**URGENT: MEDICAL DEVICE CORRECTION**

**InstaClear Sheath**

Date: May 1, 2024

## InstaClear™ Lens Cleaner Revisions

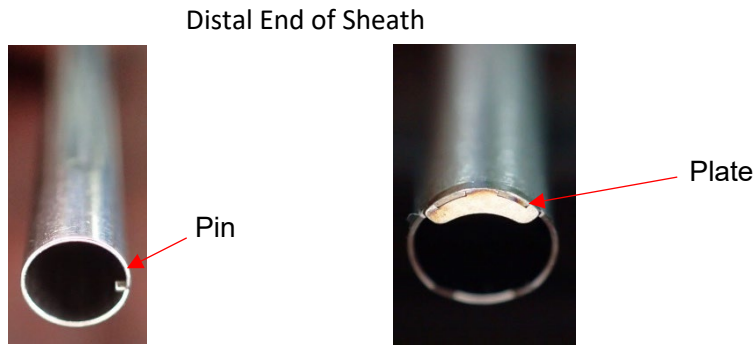
Olympus is taking this corrective action after investigating a complaint for an InstaClear Sheath (Model # LCS4K30BTOL) in which the plate on the distal end of the sheath broke off during a procedure. Olympus has received sixty-seven (67) complaints across all sheath models related to breakage or damage to the pin or plate at the distal end of the InstaClear Sheath since the product was launched in 2016. Four (4) complaints were reported as serious injuries. The image of the pin and plate is below.

The pin or plate breaking off the tip of the InstaClear sheath can lead to potential patient harms. Increased force when applying the sheath to the rigid scope can damage the pin or plate and increase the risk of dislodging the

pin or plate from the sheath. This may lead to a delay in initiating a procedure or a foreign body (broken pin or plate) in the patient, potentially requiring imaging and prolonged operative time to locate and remove the broken piece. Additionally, tissue injury or bleeding could occur due to exposed sharp edges. A broken piece remaining in the patient could potentially lead to an inflammatory reaction (granuloma), or infection.

In an effort to maximize patient safety and mitigate any immediate and potential risk to patient health, Olympus is notifying users of these complaints and is providing the attached labeling Addendum with updated instructions for sheath installation and setup. The Addendum includes new Warnings to inspect the InstaClear Sheath upon removal from the patient to determine if there are any missing components and to immediately retrieve any fragments retained within the patient.

Do not force the sheath hub all the way to the lightpost as a gap between the sheath hub and lightpost should be seen. If a gap is not visible, damage to the distal end may occur. After sliding the sheath over the scope, inspect the sheath distal end to ensure it is not damaged, loose, bent, or broken, and nothing protrudes from the end.
